TECHNICAL DRAINAGE STUDY RESPONSE TO CCRFCD COMMENTS

Skye Canyon Detention Basin 2

**Subject: Addendum to the Technical Drainage Study for Skye Canyon Basin #2 (DS4813C)
(CCRFCFCD No. 18-10010)**

**DISTRICT COMMENT(S): SKYE CANYON- DETENTION BASIN #2
(DS4813C) (RFCD No. 18-10010)**

NINETY-FIVE MANAGEMENT LLC
SKYE CANYON DETENTION BASIN 2
PMF OVERFLOW SPILLWAY EXHIBIT

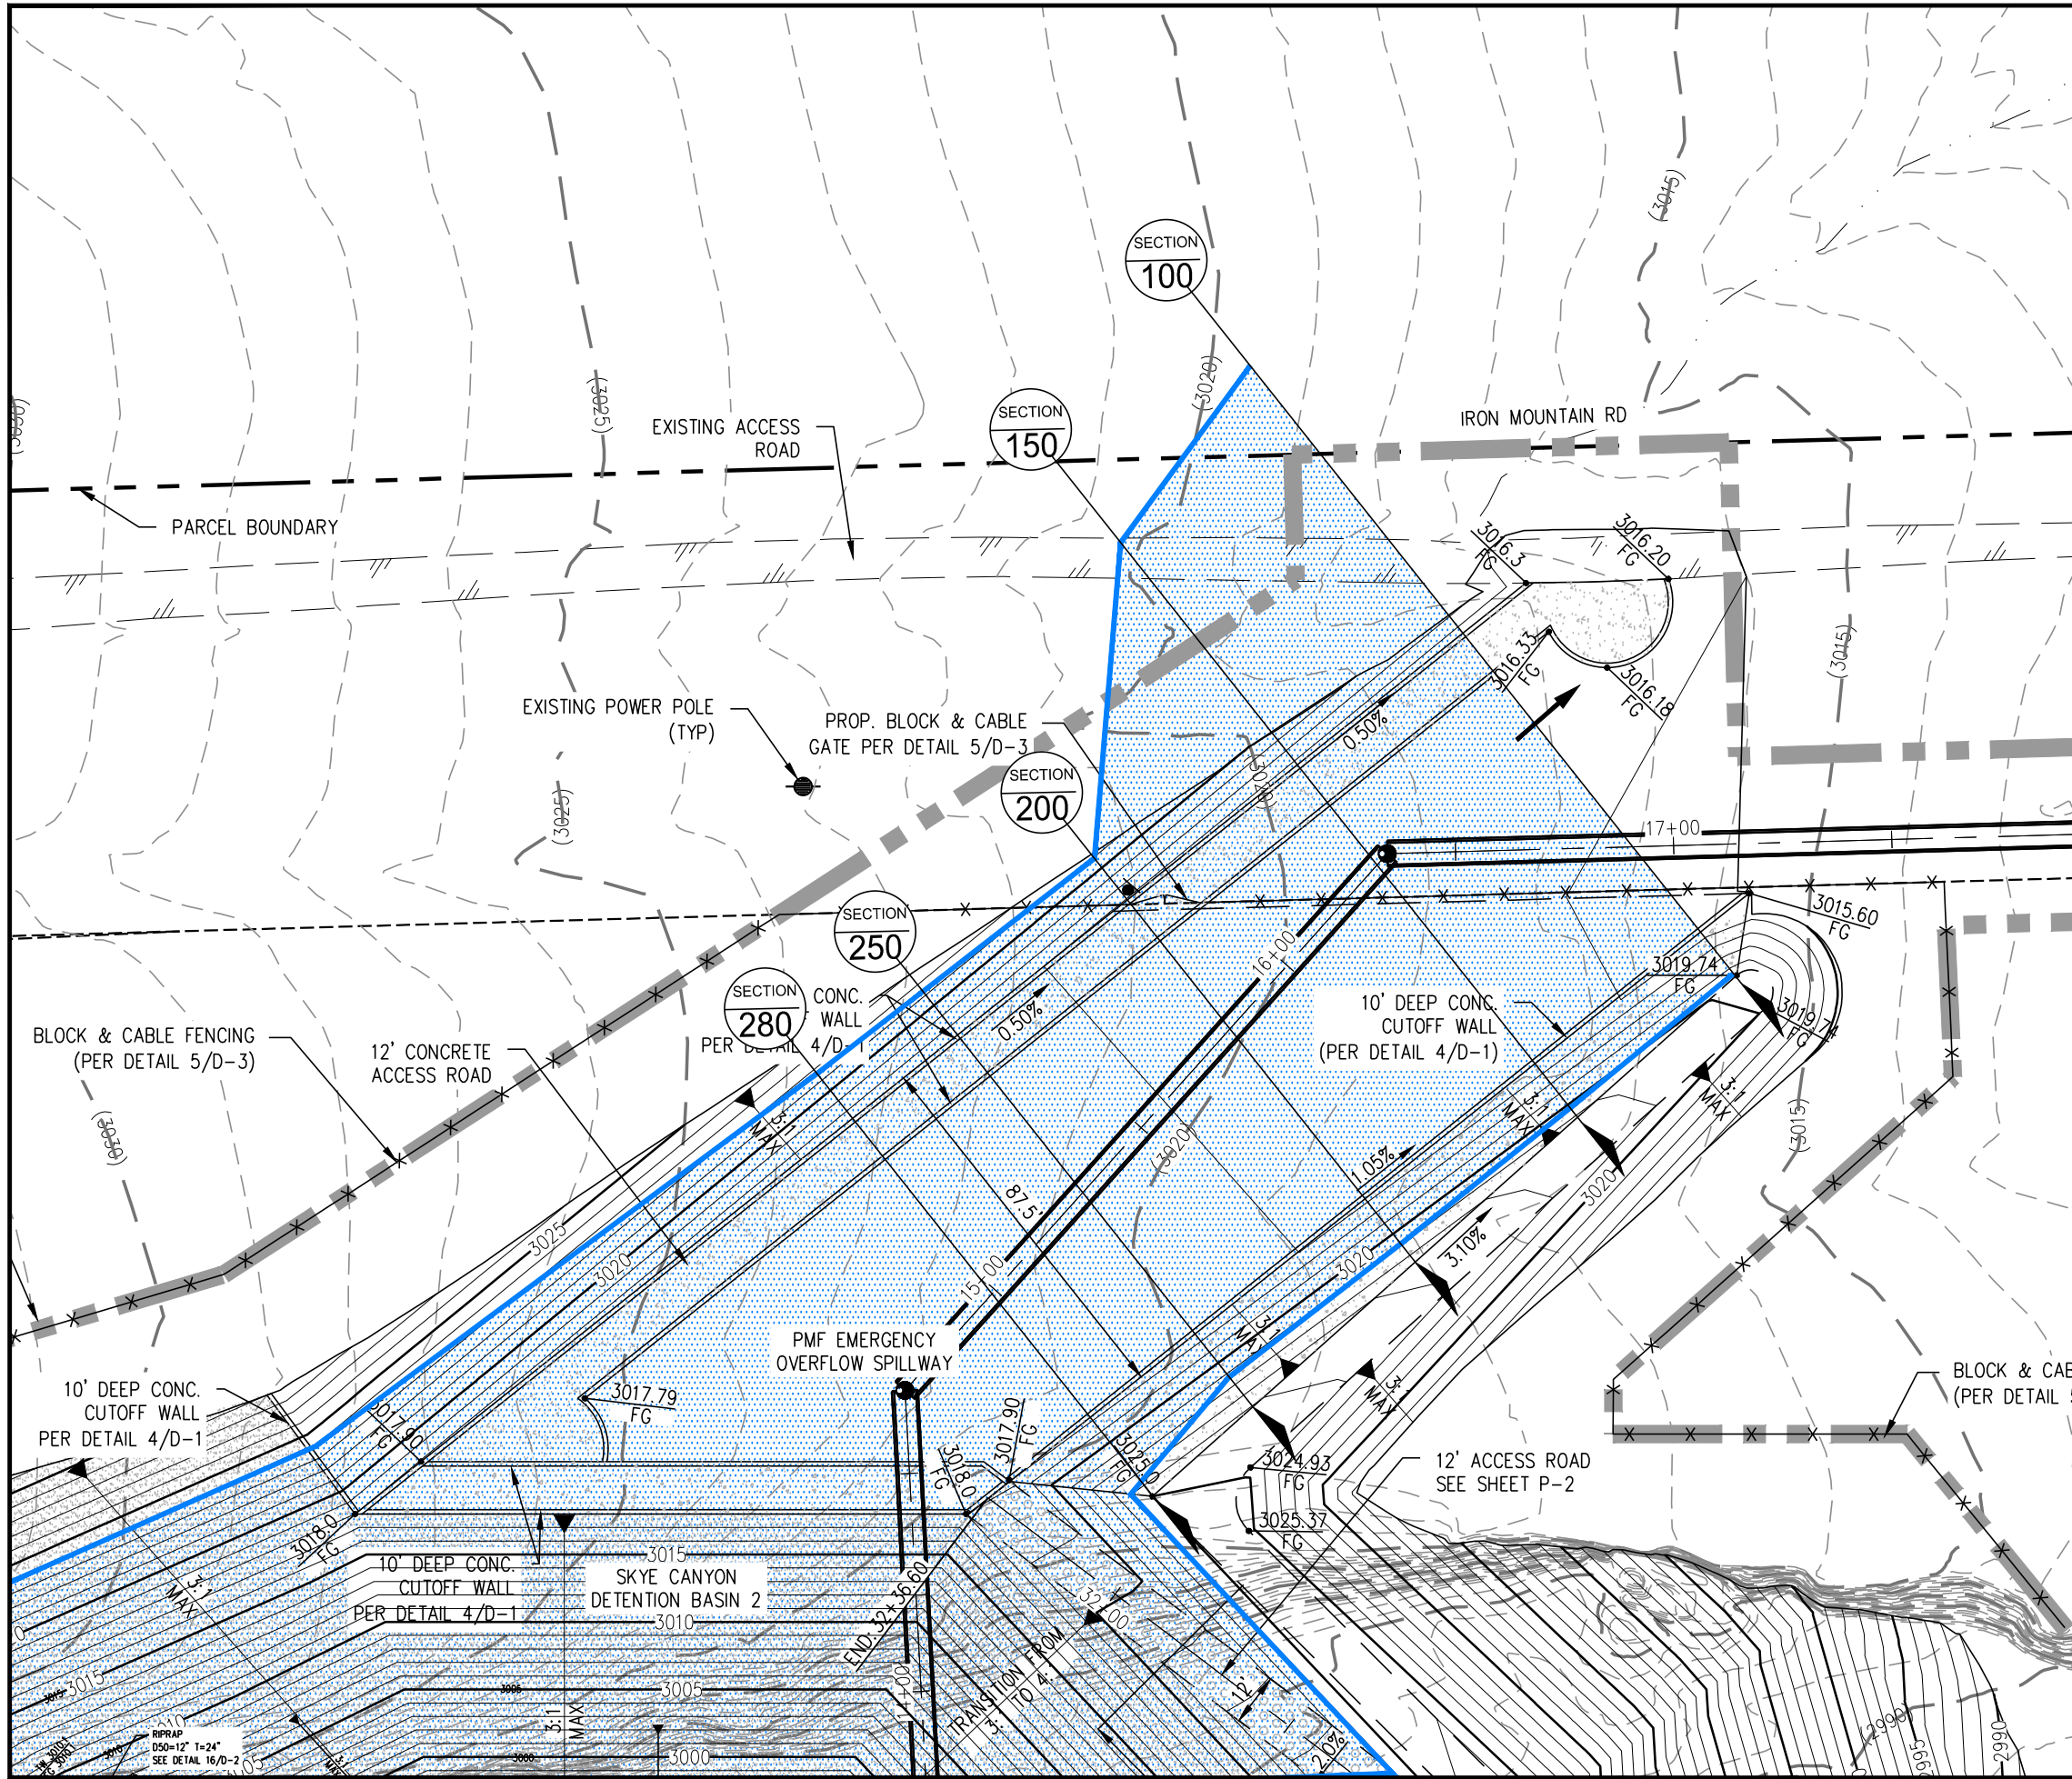
2. **Comment:** *Provide discussion and emergency spillway sizing calculations to support the currently proposed 12-ft spillway as shown on Details 1/D-2 and 3/D-3. Additionally, provide detail cross section for the entire emergency PMF spillway section to include the slope to the base of the spillway at the 102-ft Nevada Energy Easement.*

Response: The emergency spillway for the basin is located such that the overflow passing out of the basin during a PMF event will be discharged into the future Iron Mountain Road alignment, which is considered to have the least impact to future development. The crest is proposed diagonal to the spillway alignment, resulting in a 140-ft crest length. A Flowmaster generic weir calculation was performed with the original TDS submittal showing a 5.79-ft depth, which resulted in over a foot of freeboard to the adjacent east spillway embankment. An updated calculation (see Appendix) has been performed using a broad-crested weir calculation that takes into account the downstream tailwater depth. The results of this calculation show a depth over the weir of 5.85-ft, which is within a tenth of the original calculation, and still provides greater than a foot of freeboard during the PMF event.

A HEC-RAS model was performed (see Appendix) for the spillway channel, which narrows to an 87.5-ft base width downstream of the 140-ft long weir crest. Results of the model show a flow depth of 4.26-ft immediately downstream of the weir, which is the value used for the tailwater in the weir calculation. The flow depth decreases at each downstream cross section to a depth of 3.84-ft at the termination of the east embankment. Flow velocity and scour potential, and measures proposed to

Section 3/D-3 is revised to show the section through the spillway to the Nevada Energy Easement.

Trash Rack Capacity Calculation

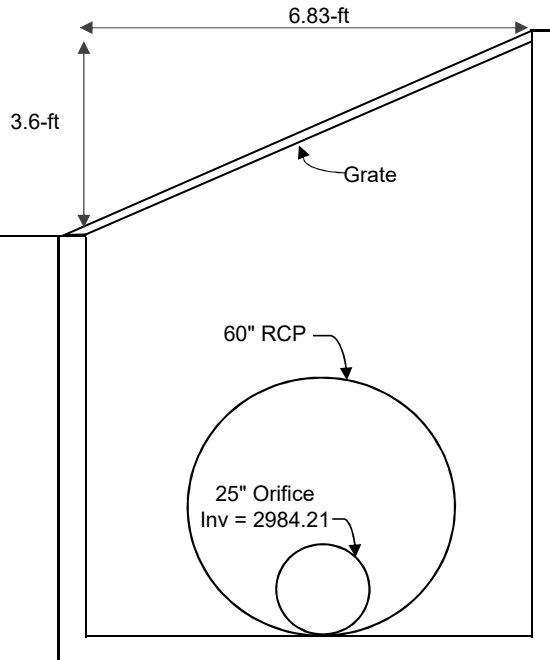
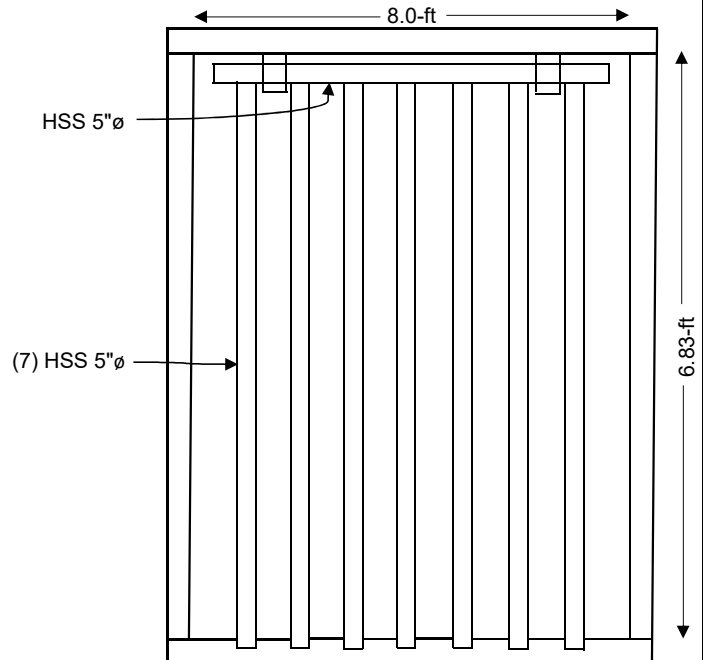
6. Provide a copy of the approved Emergency Action Plan (EAP) for the proposed detention basin to the District upon availability.
7. Provide trash rack capacity calculations to verify that the grate opening is adequate with 50% clogging factor.

Response: Trash rack capacity calculation included in Appendix. Computations verify adequacy with 50% clogging factor.

Capacity of grate with 50% clogging factor exceeds capacity of orifice outlet, therefore grate size is sufficient.
